SOLICITATION/CONTRACT/ORDER FOR COMMERCIAL ITEMS				1. REQUISITION NUMBER ASLBP-95-303		PAGE OF PAGES 1 21	
OFFEROR TO COMPLETE BLOCKS 12, 17, 23, 24, & 30				5. SOLICITATION NUMBER RQ-ASLBP-95-303-MOD 2		6. MOD. 2 ISSUE DATE: 06/28/96

19. ITEM NO.	20. SCHEDULE OF SUPPLIES/SERVICES			21. QUANTITY	22. UNIT	23. UNIT PRICE	24. AMOUNT
0	THIS IS MODIFICATION 02 TO THE RFQ REFERENCED ABOVE. THE DATE FOR SUBMISSION OF OFFERS IS HEREBY EXTENDED TO JULY 15, 1996. THE TIME OF 2:30 PM FOR RECEIPT OF OFFERS REMAINS UNCHANGED.						
0	SUBJECT RFQ IS HEREBY MODIFIED						
(Attach Additional Sheets as Necessary)

2). Article A.1 Statement of Work, is hereby deleted and the following Article A.1 is substituted therefor. All changes or additions to the original Statement of Work are marked in boldface print.

Drawing Shows Witness Camera
and Viewing Angle

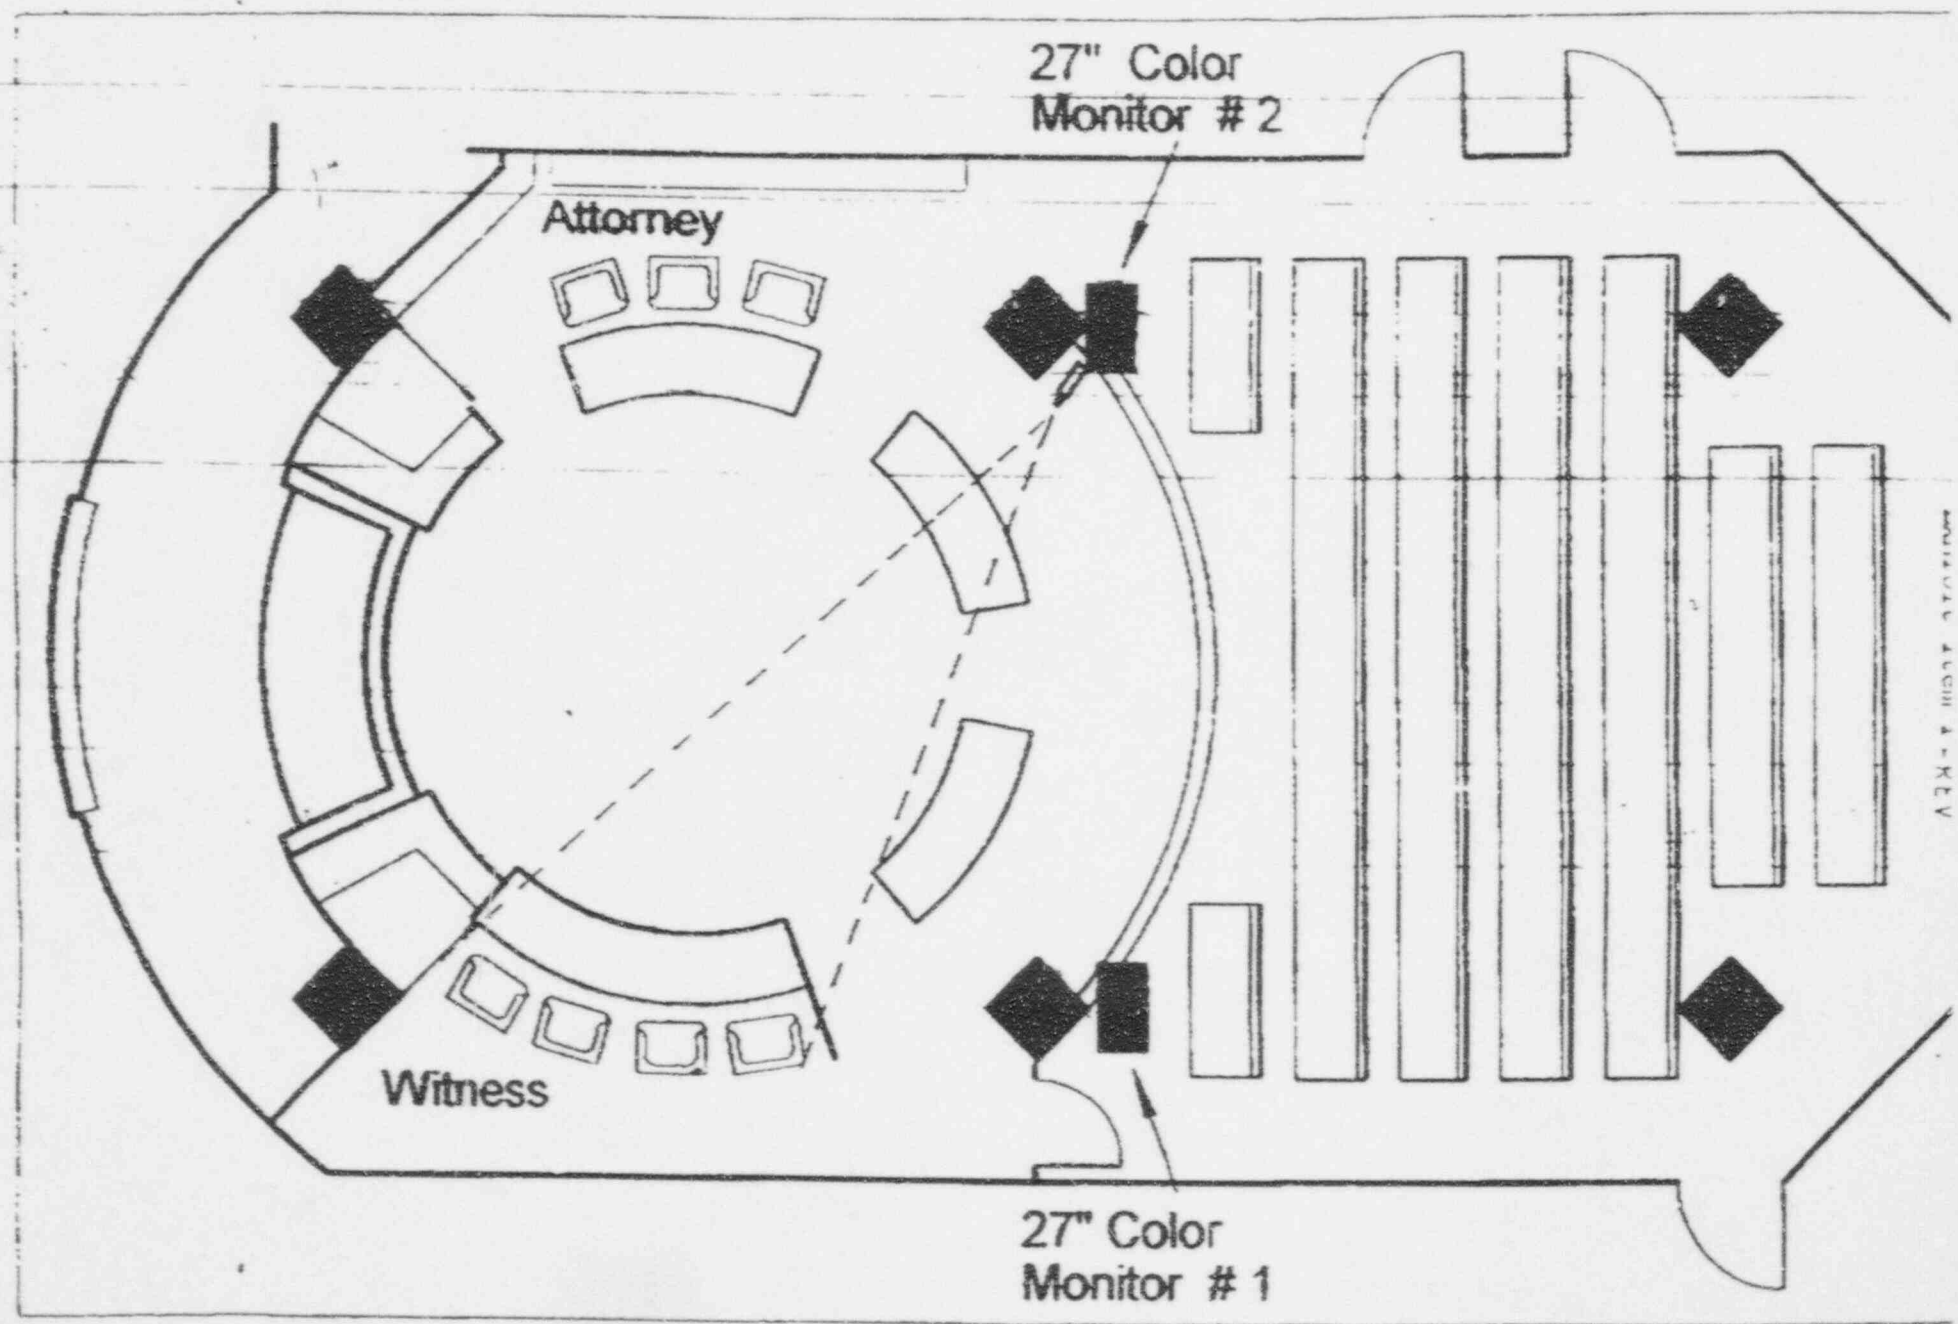
3) Exhibit Items 1-5 under Article C.1 EXHIBITS, are hereby deleted in their entirety and the following Exhibit Items are substituted therefor:

ITEM	DESCRIPTION
1-REV	Drawing showing Witness Camera and Viewing Angle
2	Drawing showing Table 1 Camera and Viewing Angle
